MEMORANDUM**To:** Matt Rasmussen**From:** J. Scott Seal, P.E.
Mark I. Christensen, P.E.
Timothy J. Thompson, P.G.**Date:** May 4, 2015**Subject:** Review Response for Retaining Wall Review – 6472 and 6498 South Bybee Drive, Weber County Parcel Numbers: 07-753-0001 and 07-753-0002 Uintah, Utah

Review Questions – TGE

**Subject: Rockery Analysis and Design
 Dauphine-Savory Piedmont Subdivision Lots 1R and 2R
 Weber County, Utah
 GeoStrata Project No. 910-001**

Rockery 1 Cross Section

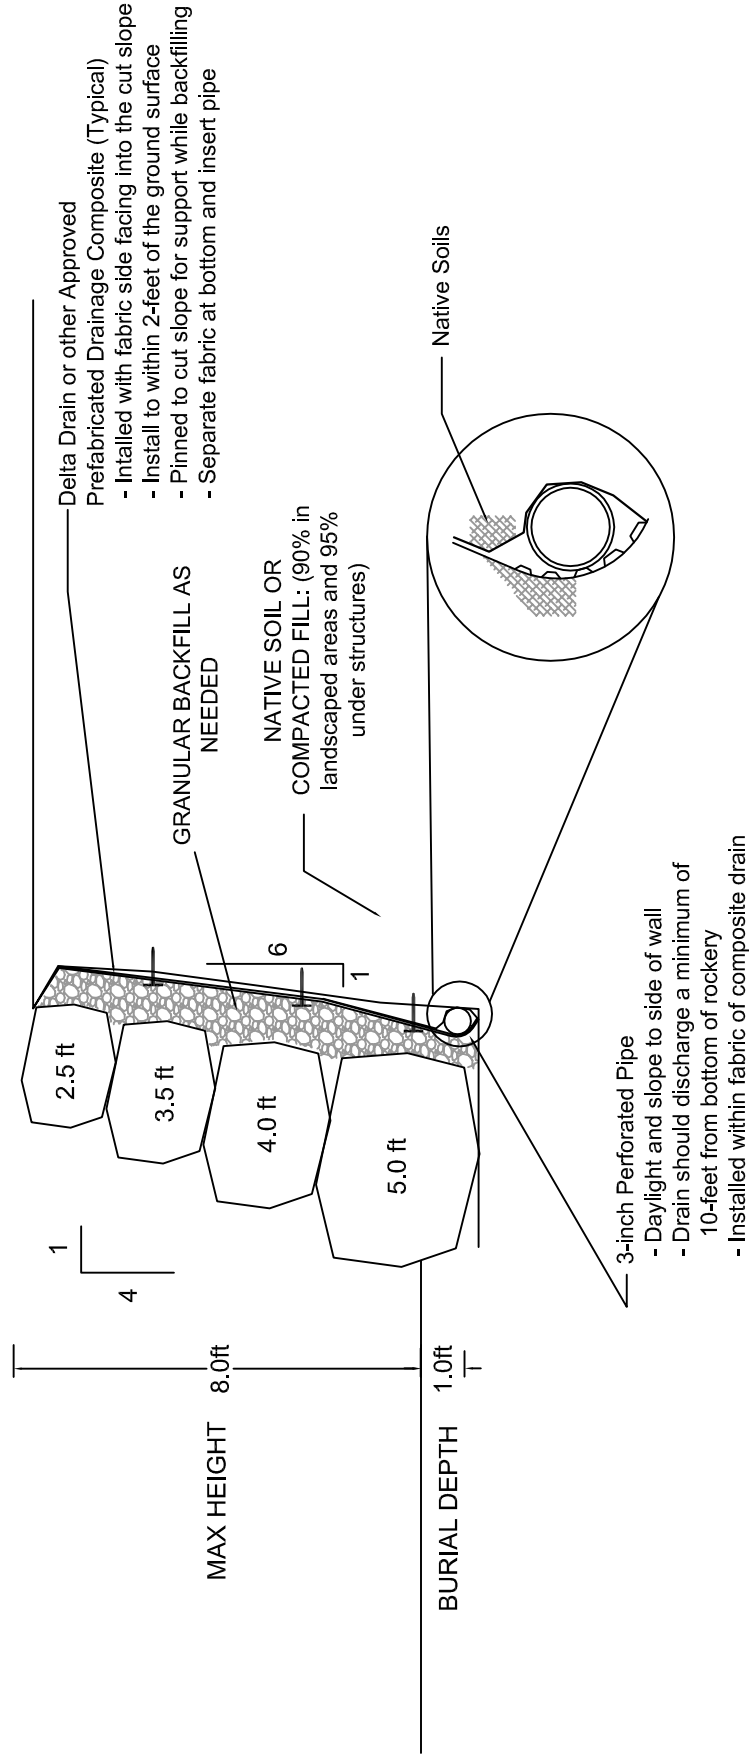
6. “The construction detail should address a drainage layer behind the wall in accordance with the FHWA document referenced in Item (1) above.”

GeoStrata Response: GeoStrata has completed the recommended construction detail discussed above.

DIRECT SHEAR TEST

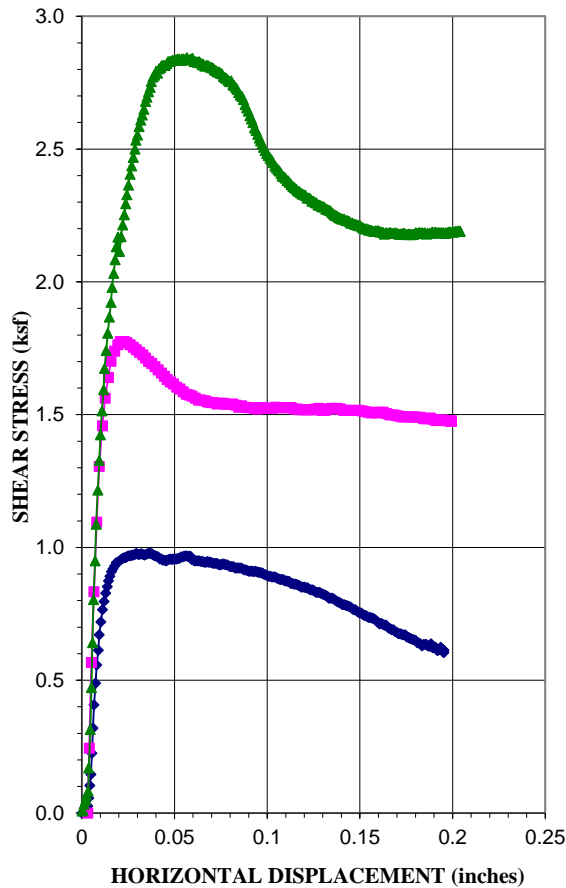
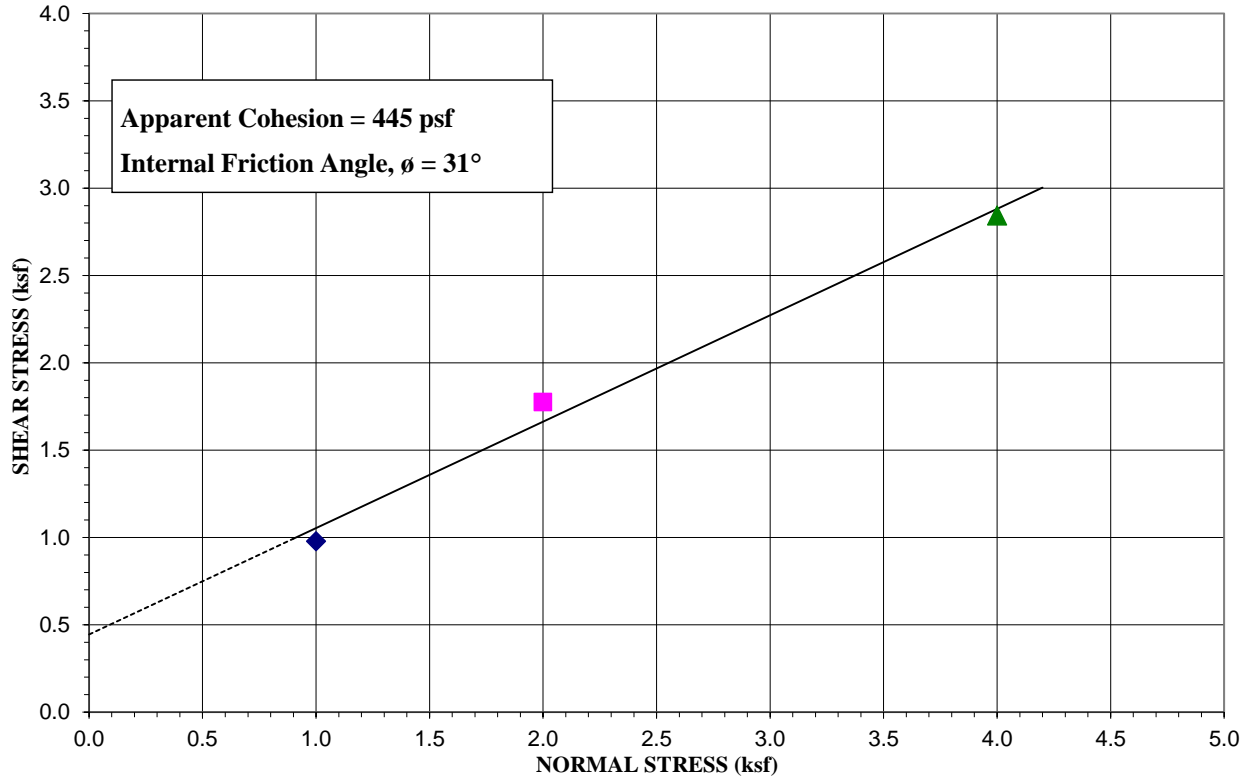
2. “The retaining wall design was based on assumed soil parameters. The soil parameters used in the retaining wall design should be substantiated with laboratory testing.”

GeoStrata Response: GeoStrata has completed a direct shear test on a sample obtained from the subject property (Trench 3). Based on the results of our testing, the soil parameters consist of a friction angle (ϕ) of 31° and a cohesion of 445 psf. Results of our laboratory testing have been attached to the end of our rockery analysis and design document as Plate D-1.
